**FINAL  
ENVIRONMENTAL IMPACT STATEMENT**

**SUPERCONDUCTING  
SUPER COLLIDER**

**Appendix 5  
Errata**

**December 1988**

Figure 5.1.4-1

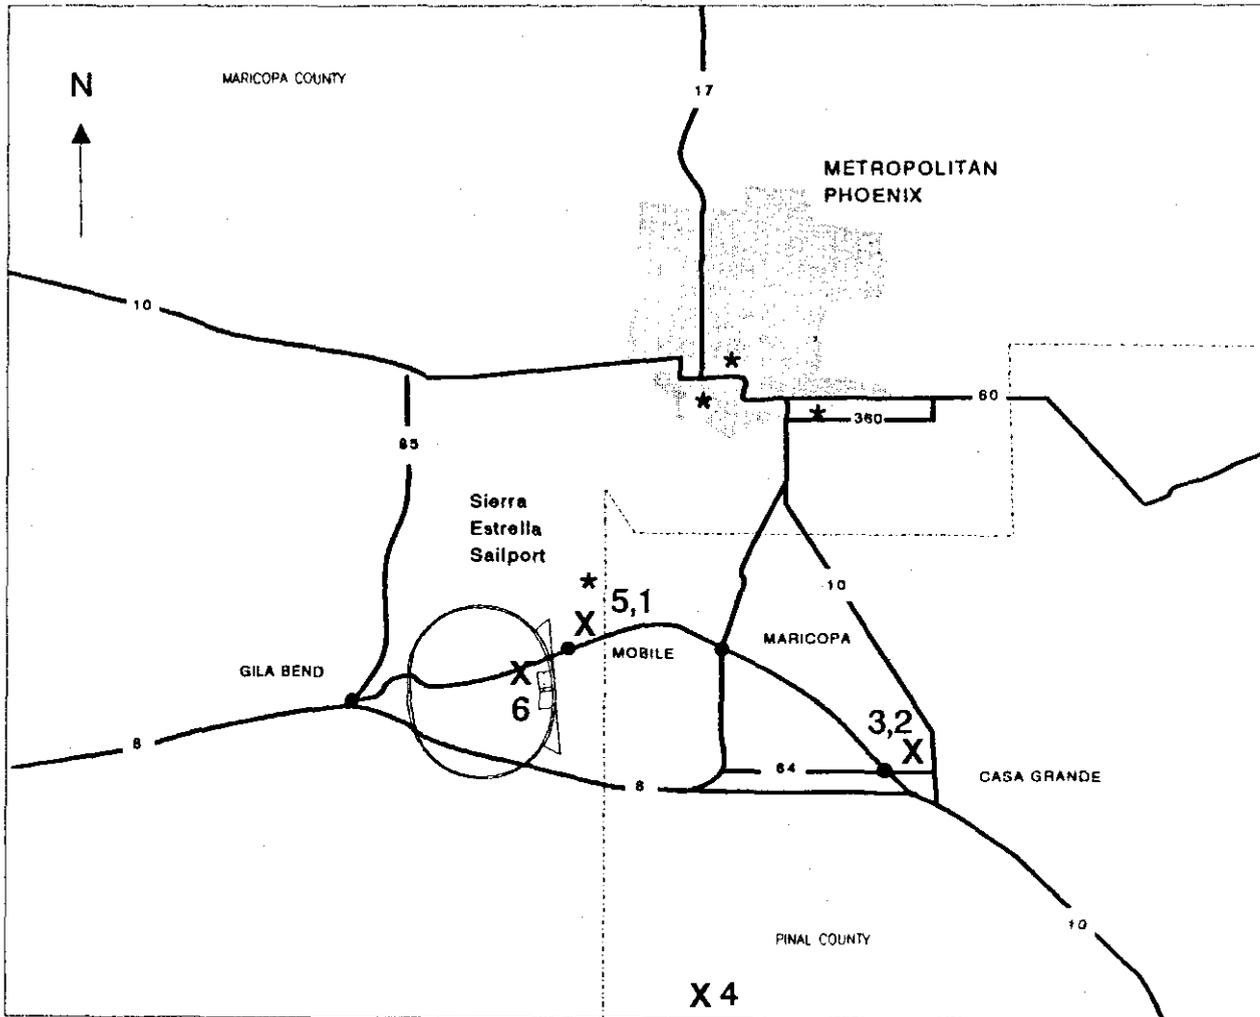
- Page 45: Figure 5.1.4-1, insert after footnote: x = Air Pollutant Source (Sources are listed sequentially in Table 5.1.4-4).
- Page 46: Section 5.1.4.3, Line 12 should read: ... the Cyprus Casa Grande copper facility ...  
Section D, Par. 1, Line 4 should read: ... Superstition Wilderness, 45 mi northeast of the center of the ring.

**Figure 5.1.10-3**  
**THE PROPOSED ARIZONA SSC SITE REGION**

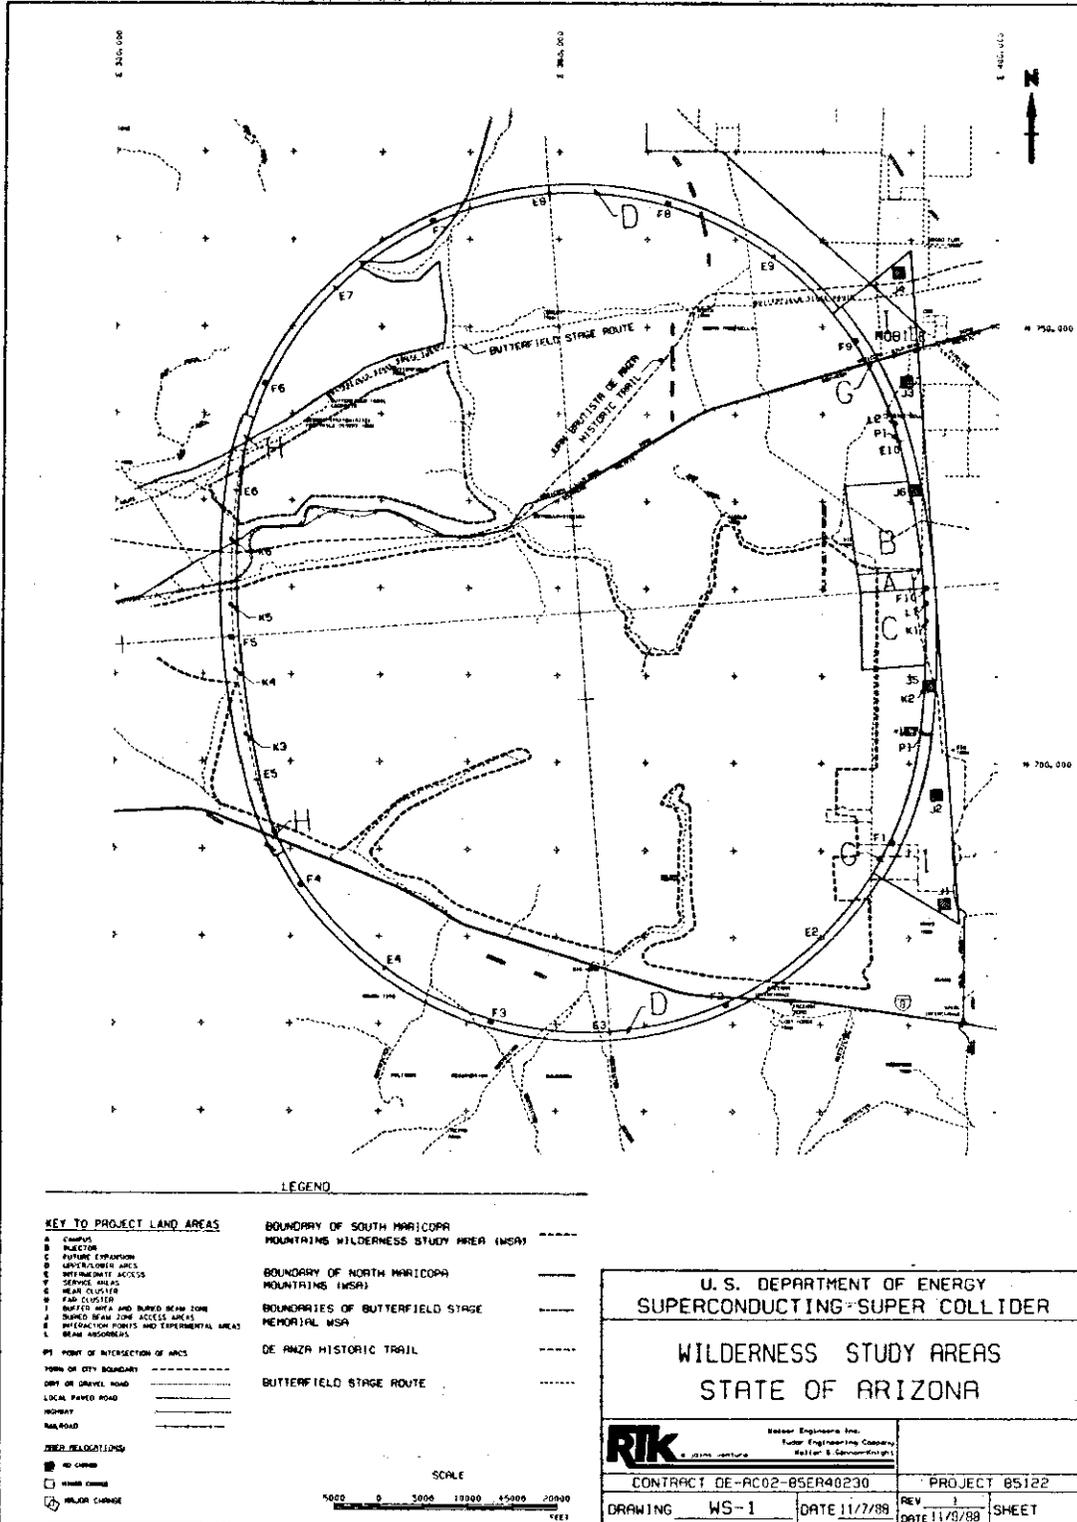
- Page 84: Par. 6, Line 2, replace ROI with: Maricopa Mountains area
- Page 95: Section G, Par. 1, Line 6 should read: in-migration ...
- Page 97: Par.4, Line 8, change Figure 5.1.9.5 to 5.1.10-3

Figure 5.2.2-1

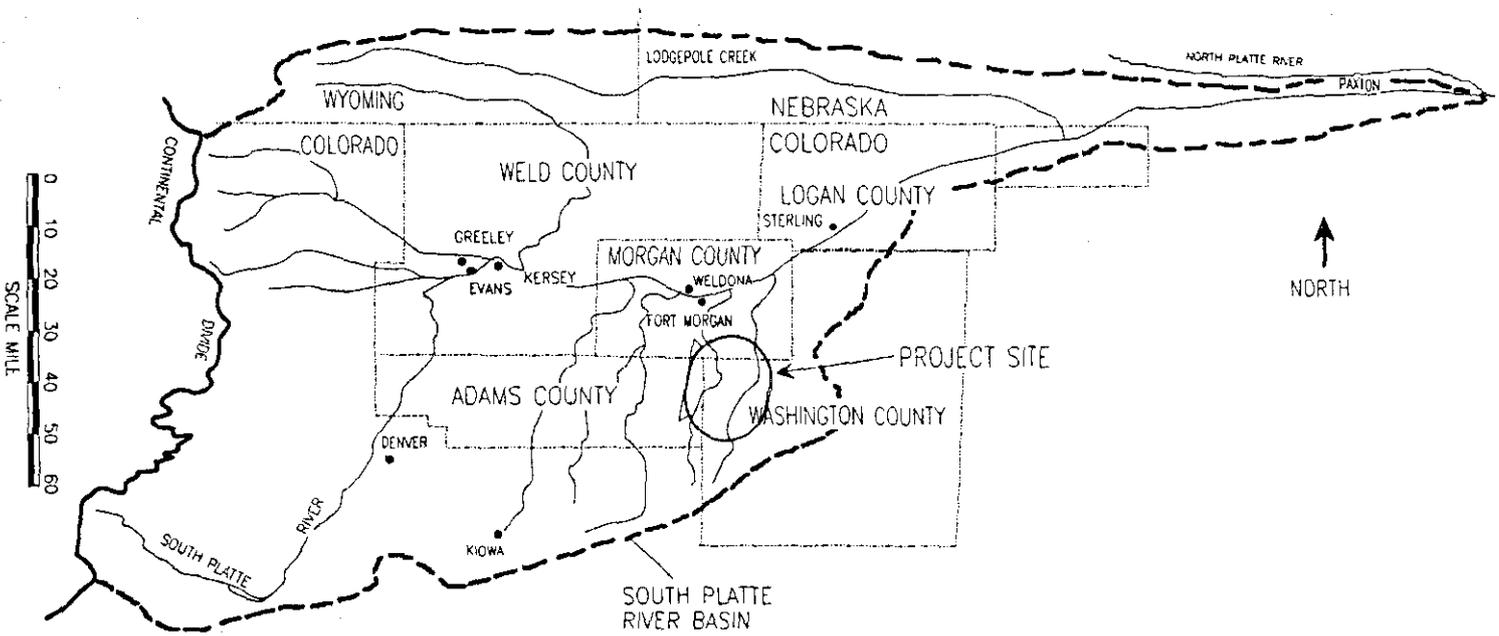
- Page 17:** Figure 5.2.2-1 source should read: U.S. Army Corps of Engineers 1977.
- Page 19:** Par. 2, Line 10, end sentence with the word floodplains. Delete rest of sentence.

Figure 5.2.8-2

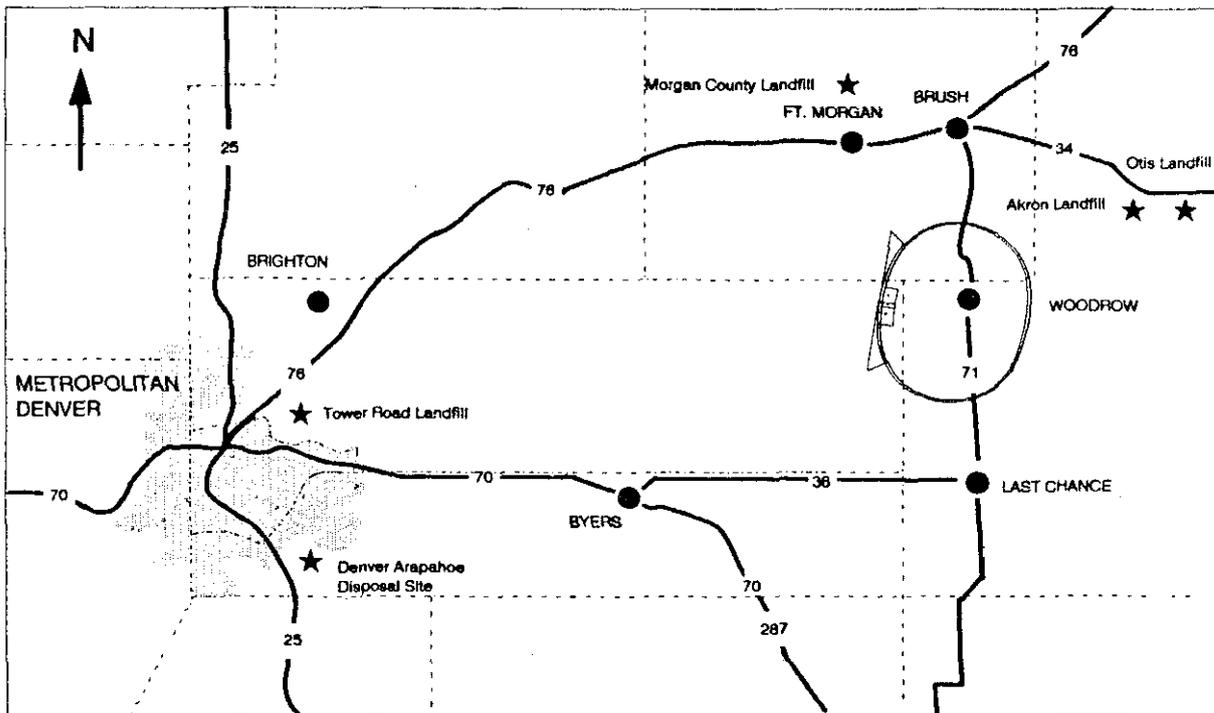
- Page 58:** See Corrected Figures section for correct Figure 5.2.8-2
- Page 59:** Section 5.2.8.3, Par. 2, after end of Line 4 rest of sentence should read: and will have capacities for 2.5 million yd<sup>3</sup> of solid and 224,000 gal of liquid wastes, with tanks for 1.5 million gal of on-site liquid storage and an interim storage facility for 600 drums."

**Figure 5.3.1-6**

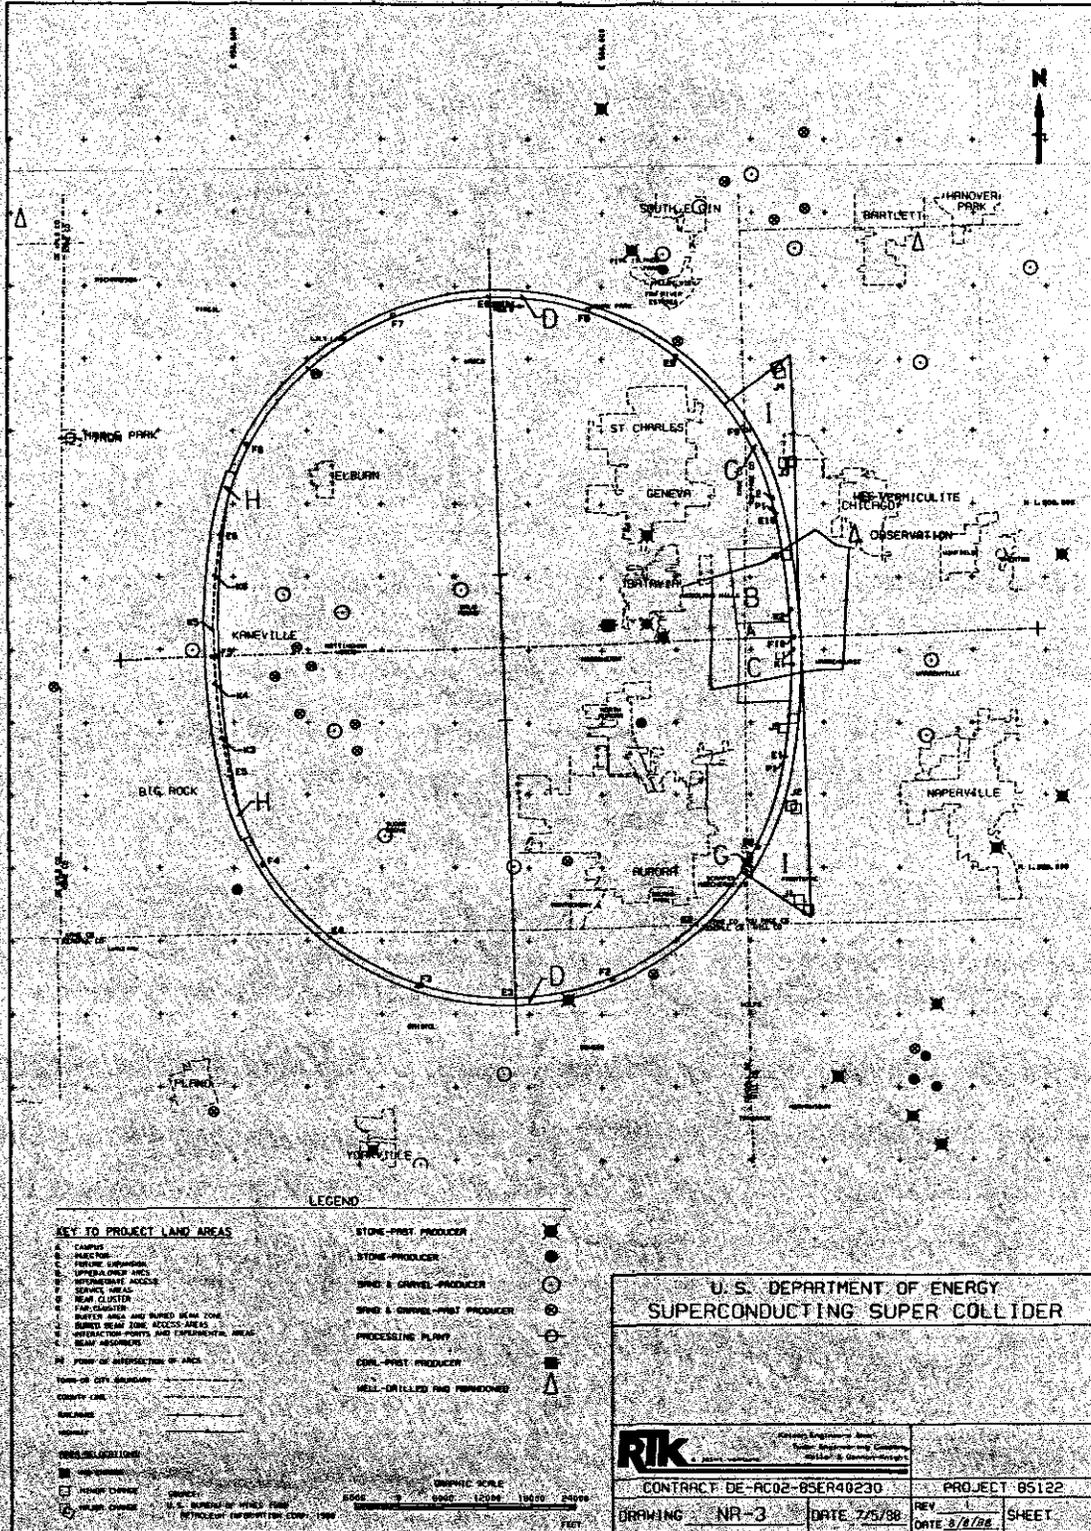
- Page 18: Figure 5.3.1-6, delete the symbol for past coal producers from the legend
- Page 19: Par. 5, Lines 3 and 4 should read: ... Sulfide mineralization (primarily pyrite) in fractures and joints was noted in ...

Figure 5.3.2-1

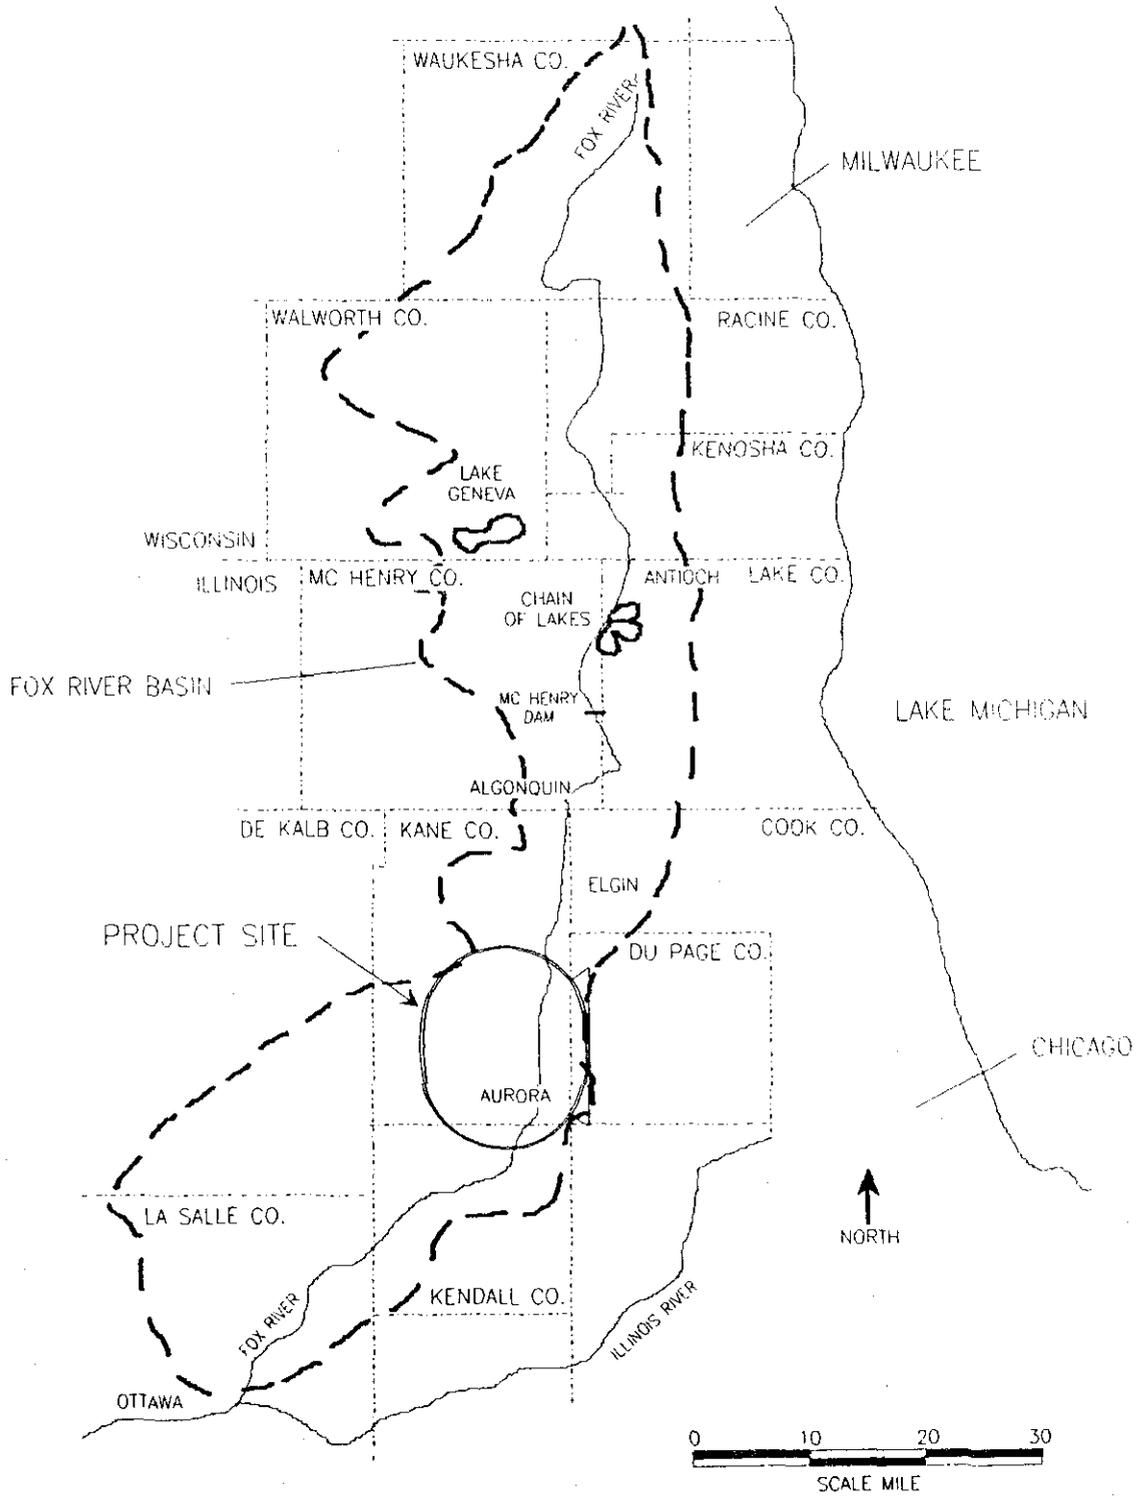
- Page 22: Figure 5.3.2-1, change Illinois River to DuPage River; source should read: U.S. Army Corps of Engineers 1984.
- Page 24: Table 5.3.2-1, the first column of data (under Drainage Area) should read: 10, 12, 14, 37, 65, 1738, 20, 18, 13, 10, 10, 12, 1592

Figure 5.3.7-1

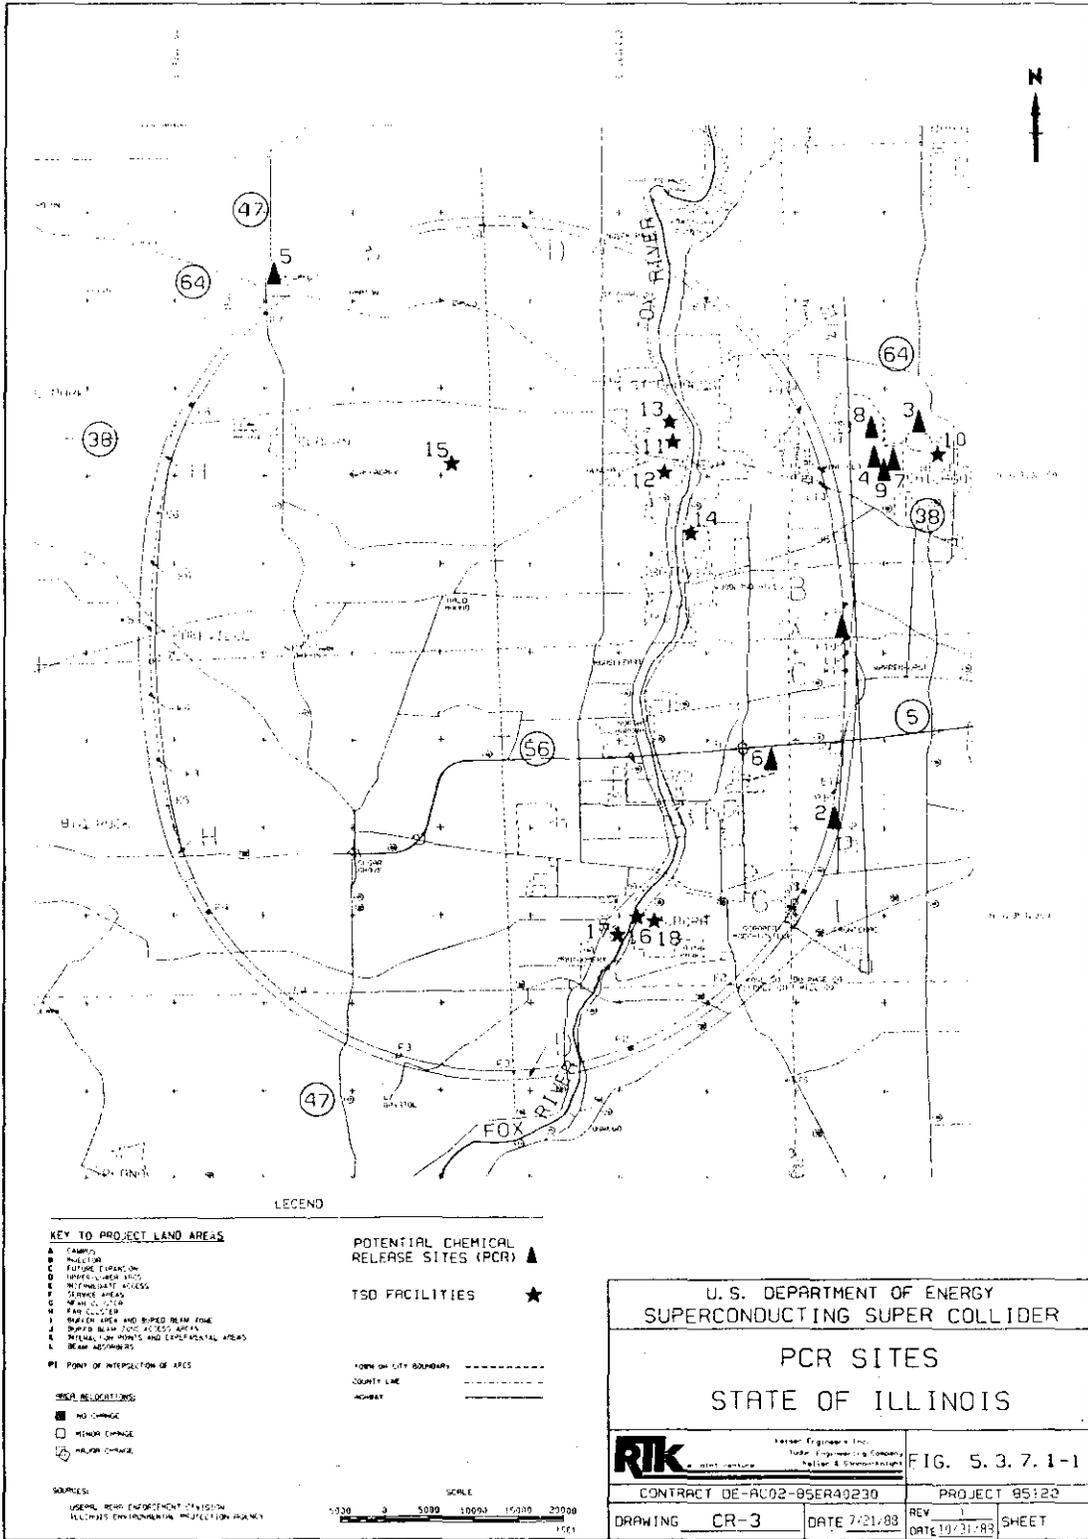
9. No Sag Products Corp.--West Chicago
- Page 73: Figure 5.3.7-1, the reference to the location of the town of Kaneville between E6 and F6 is incorrect and should be deleted

# M I C H I G A N

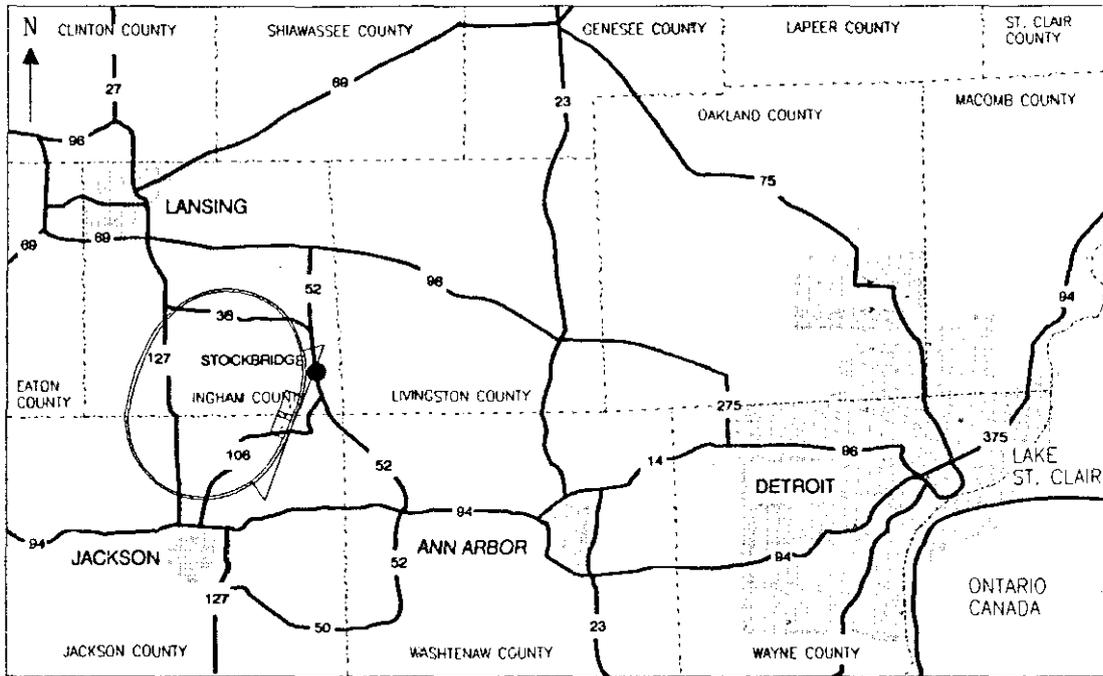
- Title Page:** Upper peninsula of Michigan was omitted from drawing insert at bottom; while drawing was intended to denote only contiguous area of state, for comparability with other state maps, upper peninsula should be added.
